PLANNING, ZONING, & BUILDING DEPARTMENT
PZ&B Staff Combination Memorandum: Architectural Commission (ARCOM) and Town Council

SUBJECT: ZON-24-0021 (ARC-24-0033) 1356 N OCEAN BLVD

ARC-24-0033 (ZON-24-0021) 1356 N OCEAN BLVD (COMBO) - VARIANCE. The applicants, Gary & Kelly Pohrer, have filed an application requesting Architectural Commission review and approval for hardscape and landscaping improvements including the addition of a pergola requiring a variance. The application shall be reviewed by Town Council as it pertains to zoning relief/approval.

ZON-24-0021 (ARC-24-0033) 1356 N OCEAN BLVD (COMBO) – VARIANCES. The applicants, Gary & Kelly Pohrer, have filed an application requesting Town Council review and approval for two (2) variances; (1) to exceed the maximum height permitted for a pergola structure, and (2) to decrease landscape open space below minimum permitted. The Architectural Commission shall perform design review of the application.

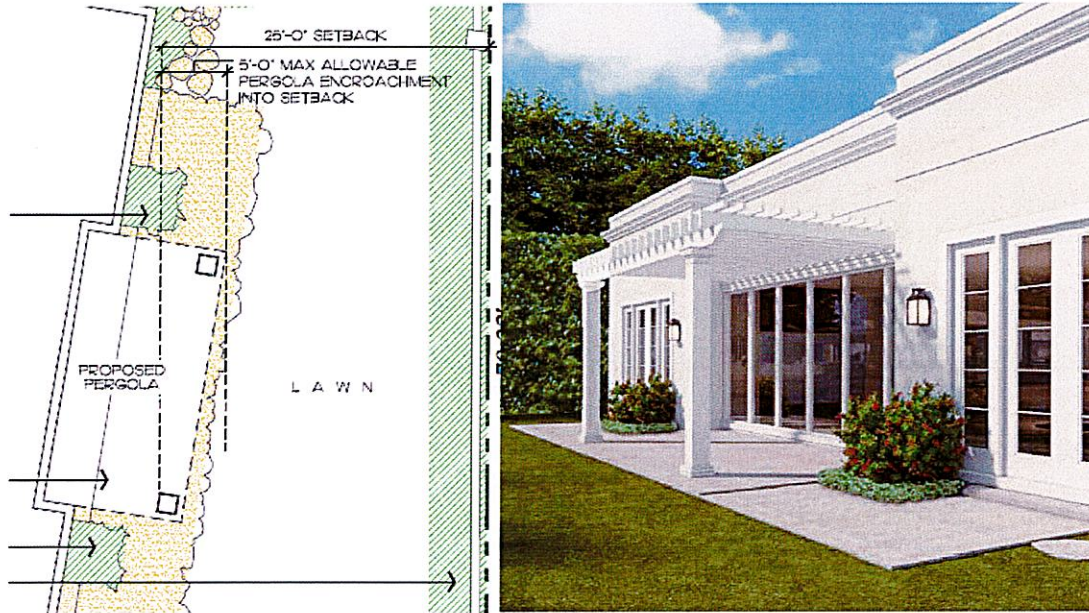
The proposed pergola necessitates a variance due to its height exceeding the maximum allowed.

The structure is to be installed on the east side of the house, positioned above existing windows that are over 9'-0" in height, within the required side street setback. Installing the pergola at a height of 9'-0" or lower would obstruct both the windows and the view.
